PONTIAC

Service Craftsman News

No. 1 S-268

January, 1955

Fig. 1 Valve Stem Oil Splash Shield Installation
Tools - J-5961

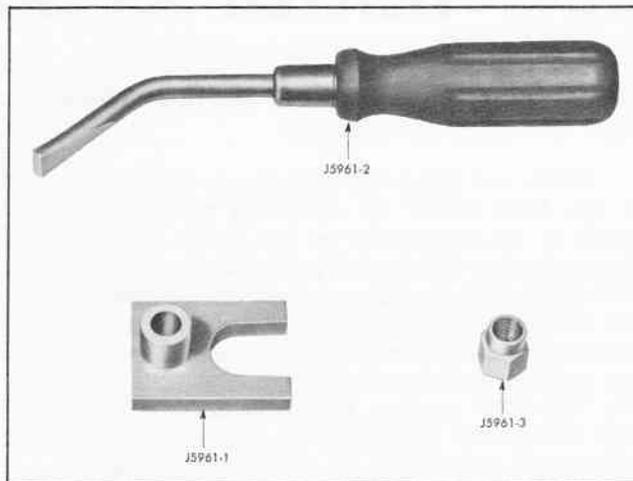
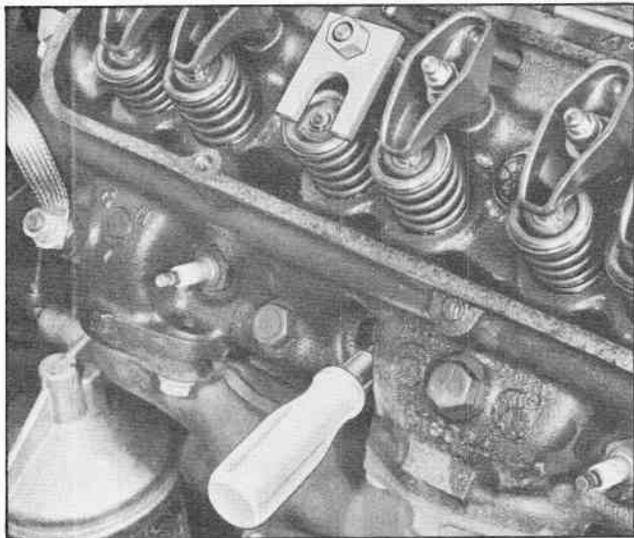
In order to reduce to an absolute minimum the possibility of excessive oil consumption, a manufacturing change has been made releasing a new intake valve stem oil splash shield, part #520996. Starting with car engine number 54487 these shields were installed on all engines.

To simplify the installation of this shield and also to replace valve stem oil seals and valve springs, a new tool #J-5961 valve spring compressor set (Fig. 1) has been released. With this tool it is possible to install the oil shields, seals, and springs without removing the cylinder head.

5. Install oil shield (part #520996) on each intake valve spring as follows:
 - a. With #1 piston on top dead center remove intake valve rocker arm retaining nut, rocker arm, and ball.

- b. Oil rocker arm stud and place Valve Spring Compressor J5961-1 and J5961-3 nut (Fig. 1) in place over stud and against valve spring retainer cup (Fig. 2).

- c. Place Valve Holder J5961-2 (Fig. 1) in spark plug port and position end of holder against head of valve (Fig. 2).
 - d. Turn down nut of compressor to compress valve springs while holding valve up with valve holder. Remove valve spring retainer cup locks (keepers), back off on J5961-3 nut and remove J5961-1 compressor, valve springs, and retainer cup; remove and discard oil seal from valve stem.

Fig. 3 Installation of #521090 Brace Assembly

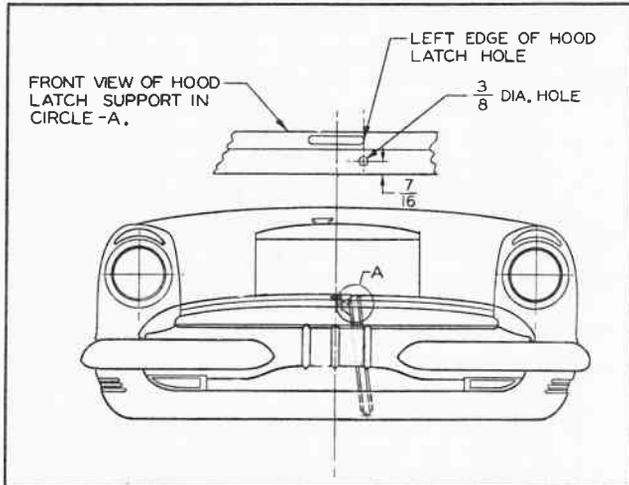
In all cases of excess movement of the front of hood first check to be sure that second type hood latch striker and fender support brace assembly (521090) has been installed. All second type braces have a screw installed in the $\frac{3}{8}$ " hole shown in Fig. 3. If the second type brace is not installed, install as outlined in steps 1 through 5 below before proceeding. If this brace is installed, proceed from step 5 and complete balance of procedure.

1. Raise hood.
2. Remove old brace assembly (vertical brace, left of center).
3. Drill a $\frac{3}{8}$ " hole in the Hood Latch Striker and Fender Support from the front of the car as shown in Fig. 3. Punch hole for drill $\frac{7}{16}$ " up from lower edge of Hood Latch Striker and Fender Support and in line with left edge of hood latch hole and on top of the support.

4. Place new brace assembly in position and install all 5 screws finger tight, then tighten. NOTE: Use 445610 screws and plain washers (a number 20-9 x $\frac{3}{4}$ hex head type A Tap zinc-plated) to secure the brace assembly to the support at top. If this screw is not available a $\frac{5}{16}$ bolt, lock-washer and nut may be used.

Fig. 4 Reinforcement Assembly #521158 Installed
(Radiator Removed to Facilitate Photography)

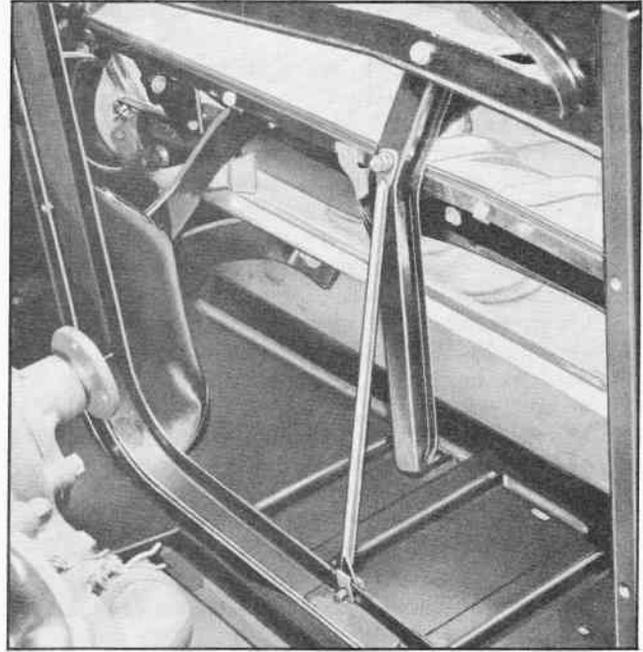
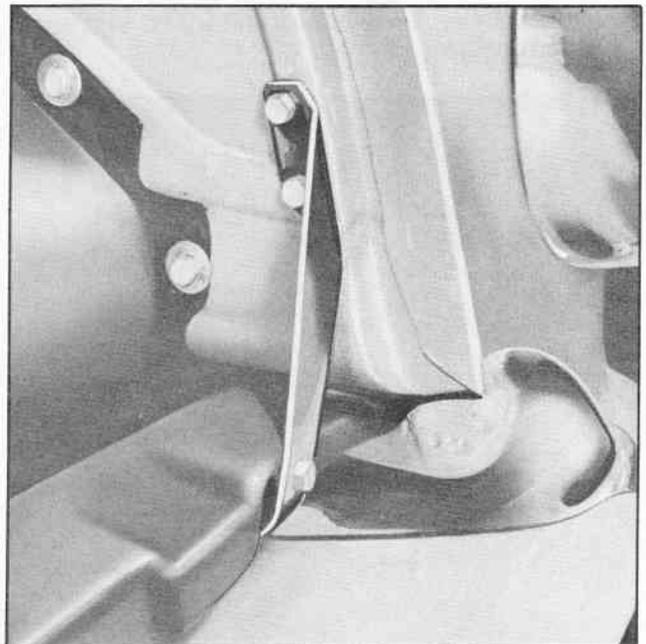
After the second type brace, Part #521090, has been installed, additional rigidity of the hood latch striker and fender support can be obtained by installing reinforcement assembly, Part #521158, from the

rear of the hood latch striker and fender support brace assembly, Part #521090, to the radiator support as shown in Fig. 4. (This part cannot be installed on an air conditioning equipped car.) Also, fender to striker support braces, Part #521097 (R.H.) and #521098 (L.H.) can be installed as shown in Fig. 5. These parts are now being used in production.

Fig. 6 Reinforcing Strip #521388 Installed

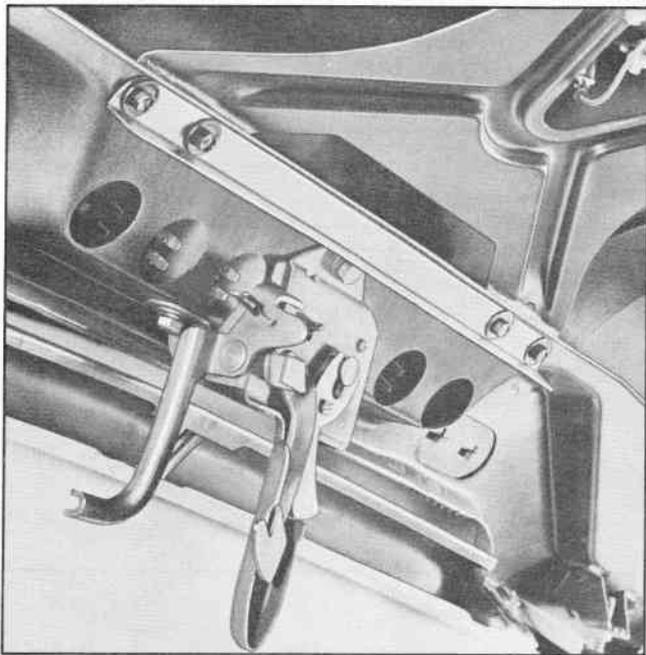
front end of the hood to which the latch assembly is fastened. This deflection can be observed at the upper of the three latch attaching screws by moving the latch guide fore and aft while the hood is open. Deflection can be minimized by installing a reinforcing strip, Part #521388, between the four screws, two of which will be seen about 6" to the right and left of the latch (See Fig. 6).

The reinforcement used in production under the front of the hood has been stiffened by forming a deeper flange on its upper edge.

Fig. 8 Bending of Carburetor Throttle Rod

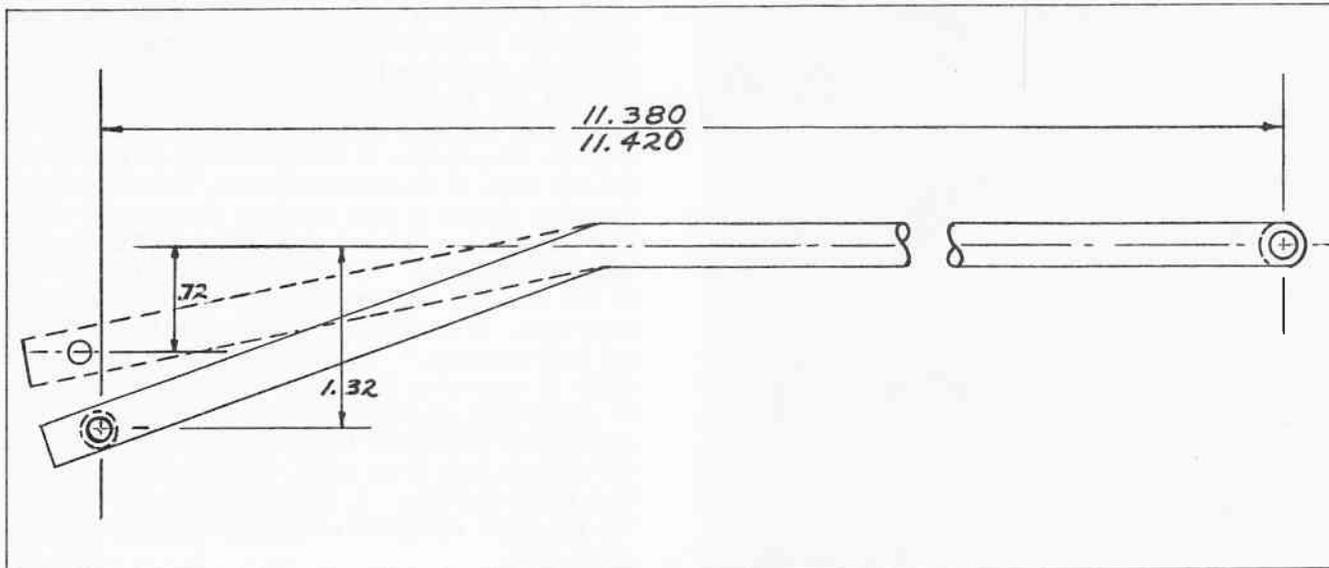
Several reports have been received concerning "lost motion" or "looseness" in the throttle linkage on early production Synchro-Mesh equipped cars. In cases of this nature check the length of the carburetor throttle rod assembly part number 519061 shown on the attached illustration. If the length of the rod is greater than 11.420" it is of the early type and could be causing excessive play in the throttle linkage.

The correction for the condition is to increase the angle of bend in the rod so that it conforms to the dimensions shown in Fig. 8. This has the effect of shortening the rod and taking up looseness in the linkage. This condition has been corrected in production.

Fig. 9 Valve Body Code Number Location

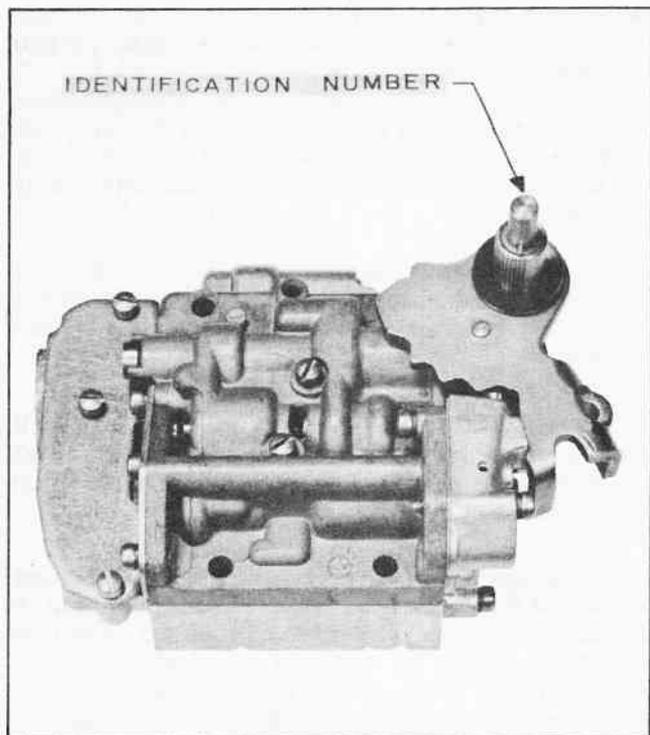
A number is stamped on the outer shaft end of the inner T. V. lever (see Fig. 9). This number is coded to match with the part number which is listed below for your 1955 and past model Hydra-Matic control valve assemblies. These numbers will not be found on service control valve assemblies.

The control valve assemblies for 1953 and 1954 are interchangeable, however, the 1955 control valve assembly will not be interchangeable, and it cannot be used on past model Hydra-Matic transmissions.
